## Descriptive Report to Accompany Hydrographic Survey H11500

Project OPR-P158-FA-06  
Approaches to Cordova, Alaska

## Revisions Compiled during Office Processing and Certification

Figure 1: H11500

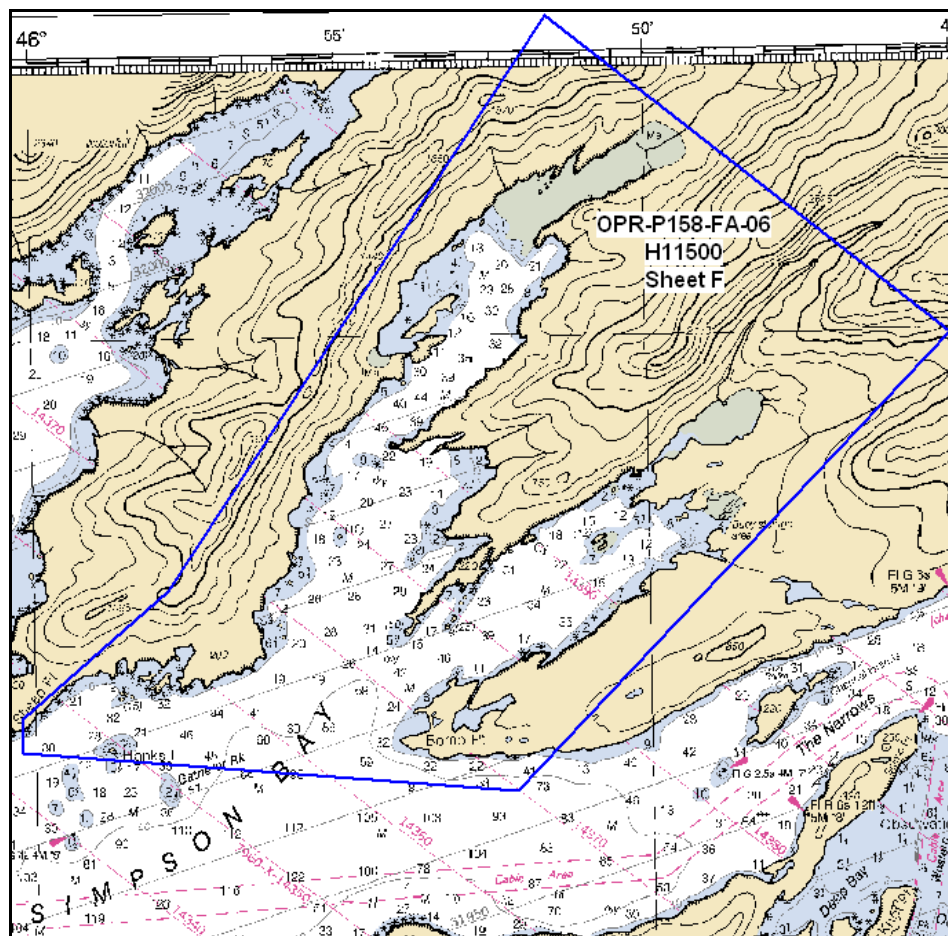
<sup>2</sup> Do not concur. 100% multibeam coverage was not obtained to the 8m curve in all cases. There were also alongtrack holidays on the southern edge of the area that do not meet the 3 nodes requirement specified in the HSSDM. The holidays occur in depths from 55m to 150m and have been examined to ensure no significant features exist in the gaps. New holidays were also created in areas where data was removed to address roll errors and vertical offsets that did not meet spec. Prior to removing data the areas were examined to ensure no significant features exist in the new gaps.

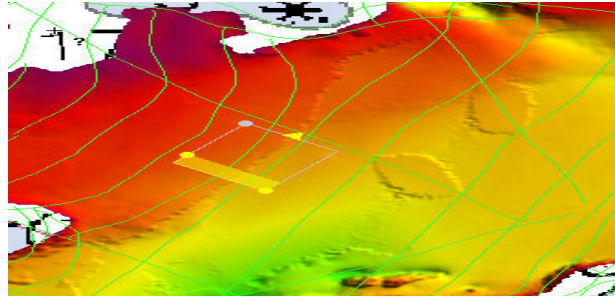
A 1.5m vertical offset in the 5m surface in the northeast arm of Simpson Bay was discovered. The offset occurs between vessel 1010 on DN249 within 2.5 hours of each other. This offset can most likely be attributed to tidal error. Offset exceeds HSSDM requirements for depths in 60m of water.<sup>11</sup>

A 1m vertical offset in the 5m surface in the northern arm of Simpson Bay was discovered. The offset occurs between vessel 1010 and 1018 on DN252 within 15 minutes of each other. The offset exceeds HSSDM requirements for depths in 40m of water.<sup>12</sup>

<sup>11</sup> Data in areas that were out of spec were removed.

<sup>12</sup> Data in areas that were out of spec were removed.

Figure 6. Close up of charted (US4AK25M) 29 meter sounding and surrounding soundings from BASE surface

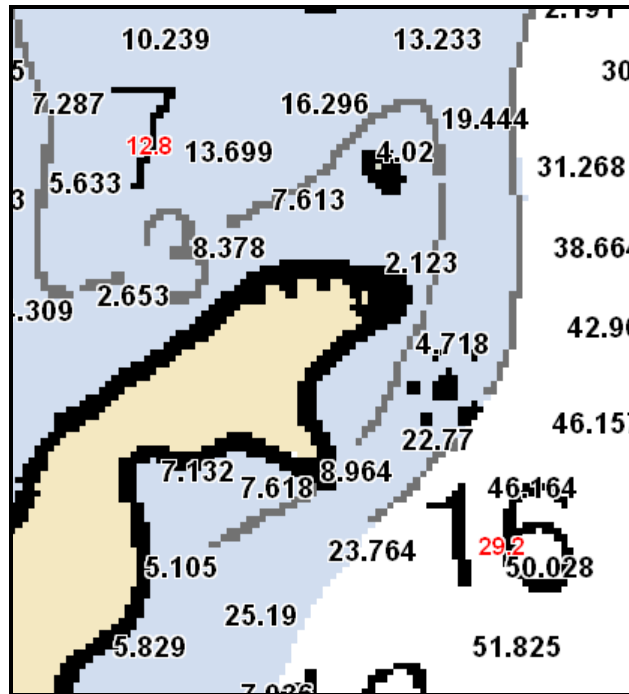
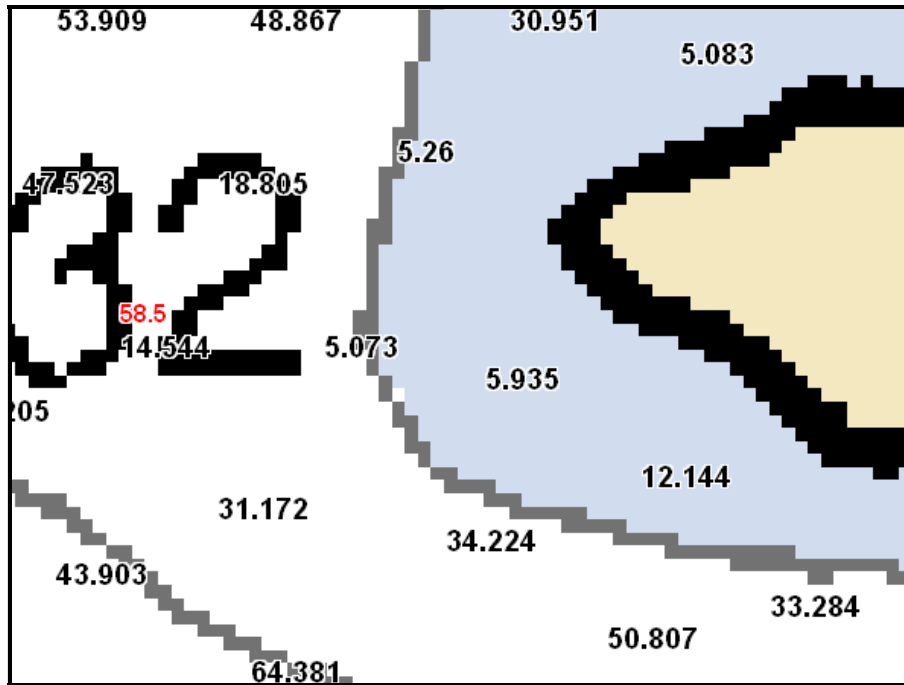
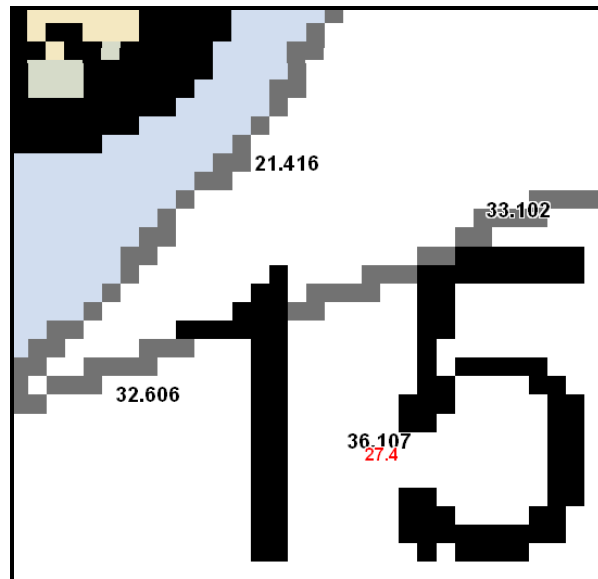
In the northwest corner of H11500 a 29 meter ENC sounding was found near a 50 meter BASE surface generated sounding (see Figure 6). East of Bomb Pt. in the southeast portion of H11500 a 58 meter ENC

sounding was found above a 14 meter BASE surface generated sounding (see Figure 7). Off the center tip above Bomb Pt. a 37 meter ENC sounding was found over a 36 meter BASE surface generated sounding (see Figure 8).

<sup>18</sup> Do not concur. When compared to chart 16709, differences up to 5 fathoms with charted soundings were noted in several areas of the survey. In the cases where the surveyed depth were shallower, the new depth was not considered significant enough to constitute a DTON.

Figure 1.2.1 DP# 12504, New Rock

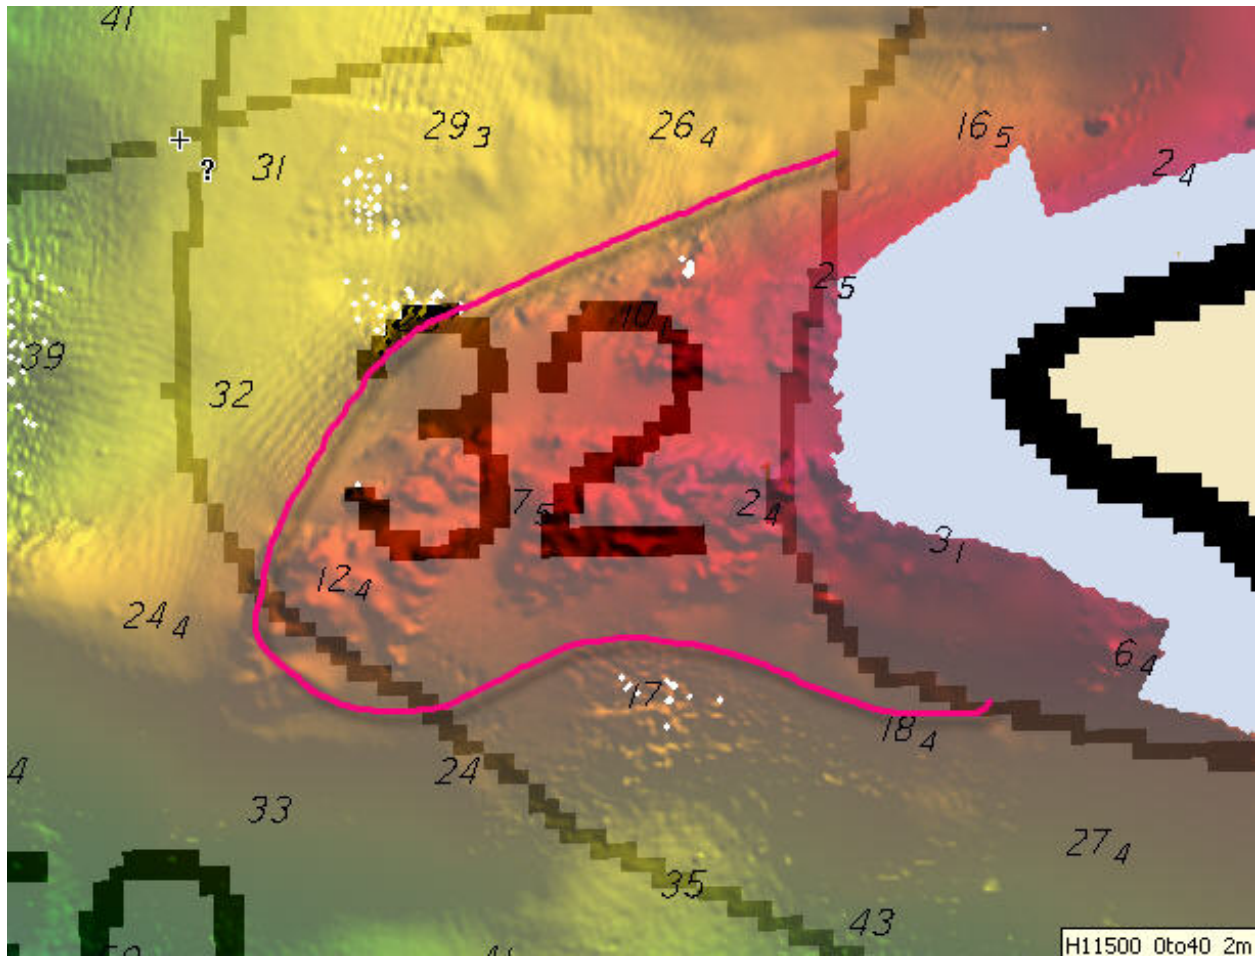
Hydrographer recommends charting new rock at position 60°40'30.529" N, 145°52'45.779" W with a least depth of -0.39m (-0.21 fm). Observed tides file used for vertical control.

Concur. DTON has been charted as a rock that covers and uncovers with least depth -0.1640 fm. Retain rock as charted.
